# UNITED STATES PATENT AND TRADEMARK OFFICE

APPLICATION NO.	FILING DATE	FIRST NAMED INVENTOR	ATTORNEY DOCKET NO.	CONFIRMATION NO.
10/600,503	06/20/2003	Ronald A. Klempner	AMMAR 3.0-001	5481
530	7590	06/17/2005	EXAMINER	
LERNER, DAVID, LITTENBERG, KRUMHOLZ & MENTLIK 600 SOUTH AVENUE WEST WESTFIELD, NJ 07090			ADAMS, GREGORY W	
			ART UNIT	PAPER NUMBER
			3652

## Office Action Summary

## DETAILED ACTION

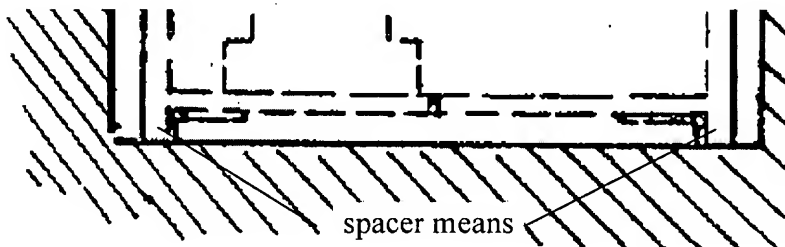
11. With respect to claim 4, Harza discloses a wall means 164 comprising spacer means as shown in FIG. 7 below.
